Shaw Street Reserve

Shaw Street Reserve received a low to moderate response rate with 12 survey responses.

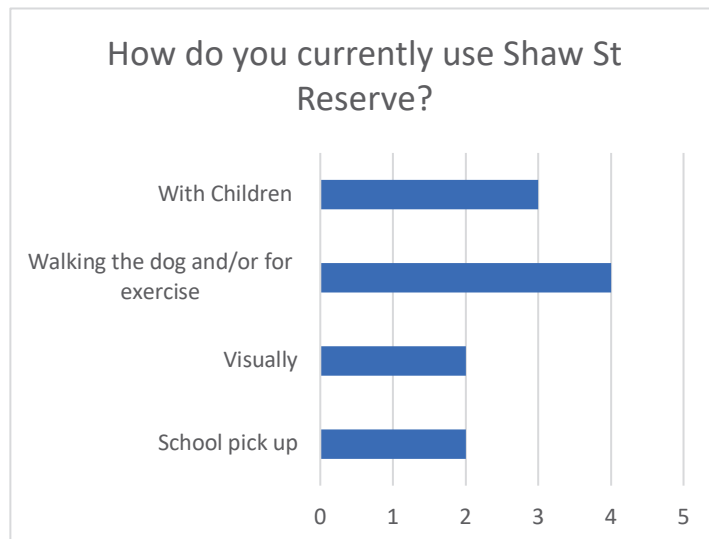
Proposed Changes Shaw Street Reserve	Support
Questions	
Basketball hoop seems unsafe as it is close to the road. Will there be barriers?	1
Will increased use of the park make it unsafe for homes/increase risk of break ins?	1
Will access to the rear of homes be impacted? The trees as proposed make access challenging.	1
More information required about playspace / Not sure what is proposed.	3
What material will be used for the paths? Prefer concrete (bitumen is sticky)	1
Will the basketball hoop be suitably fixed so it is not a hazard if children climb on it?	
What type of trees are proposed?	1
Homes are close. Having a basketball hoop feels like a safety risk and will make lots of noise.	1
Will the new shade structure be solid or shade sails (nor preferred)	1

Proposed Changes Shaw Street Reserve	Support	
Do not plant trees in the middle as it is nice to have open area.	1	A significant area of unprogrammed open space is proposed.
Extend pavement on the other side of Shaw Ave	1	Outside of project scope/budget.
Include diagonal path between Cromwell and Shaw St	1	A path crossing the reserve is proposed.
Additional seating and tables	4	Consider as part of design review.
Add bins	1	Outside of project scope/budget. Not appropriate for a local/neighbourhood park.
Add circuit path (gravel ok)	1	Not recommended to retain naturalised feel.
Add dog poo bag dispenser	1	Outside of project scope/budget. Not appropriate for a local/neighbourhood park.
Add parking	1	Outside of project scope/budget. Not appropriate for a local/neighbourhood park.
Add water bubbler / tap	1	Outside of project scope/budget. Not appropriate for a local/neighbourhood park.
BBQ undercover	1	Outside of project scope/budget. Not appropriate for a local/neighbourhood park.

No bins. Signage encouraging people to take rubbish with them	1	Bins are not proposed.
No lighting.	1	No lighting is proposed.
Sign for the reserve	1	Outside of project scope/budget. Not appropriate for a local/neighbourhood park.
Increase maintenance on existing play equipment	1	Outside of project scope/budget. Refer to Parks Maintenance.
Remove graffiti	1	Outside of project scope/budget. Refer to Parks Maintenance.
No rocks along playspace edge as these can be a hazard for small children	2	Rocks and logs are part of standard nature play offerings. They will be installed adjacent to soft fall mulch.
Add basket swing	1	Consider as part of design review.
Add volleyball	1	Outside of project scope/budget.

Not appropriate for a local/neighbourhood park.
Basketball court is a bad idea. Do not proceed.	1	Consider as part of design review.
No musical instruments in the play space. This would be too loud.	1	Consider as part of design review.
No sports goals – families bring their own	1	Consider as part of design review.
Shade cloth for the play area	1	Outside of project scope/budget. Not appropriate for a local/neighbourhood park.
Hedges around boundary to hide fences	1	Outside of project scope/budget.
Improve garden beds	1	Outside of project scope/budget. Refer to parks Maintenance.
Increase the number of trees planted along edges.	1	Consider as part of design review.

Given that there are some unresolved concerns regarding the use and function of the reserve, an onsite community meeting is indicated. The focus of the meeting will be a revised design outcome and providing detail on the following matters:

- Clarity around what specific pieces of play equipment are proposed
- Legality of the rear access into homes through the reserve
- Discussion regarding concerns about safety and noise relating to the proposed upgrades
- Discussion regarding location of playspace and provision of basketball court.

- Make revisions in line with community feedback and recommendations as budget allows.
- Conduct a site meeting focusing on responding to questions and providing more clarity around what is proposed. Ensure that the design response provides specific examples of formal and nature play to MySay and allowing an additional two-week feedback period.
- Residents will be notified of this timeframe by letter drop. Letter and second feedback timeframe shall be geared toward asking children to select which new pieces of play equipment they prefer from a set group through MySay survey response.
- Review feedback with the goal of achieving 80% support. Post final design outcome to MySay.
- Proceed to tender and implementation.

- Revise the current proposed design for Shaw Street Reserve.
- Progress to a site meeting focusing on responding to community questions.
